# CITY OF SAVANNAH

### REQUEST FOR CERTIFICATE OF APPROPRIATENESS

**MPC File No.:** 26-003779-COA

**Address:** 207 West 43<sup>rd</sup> Street

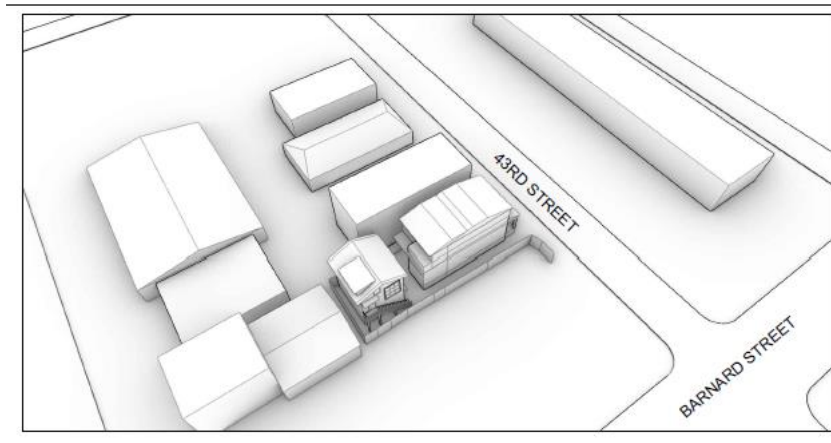
The standard is met.
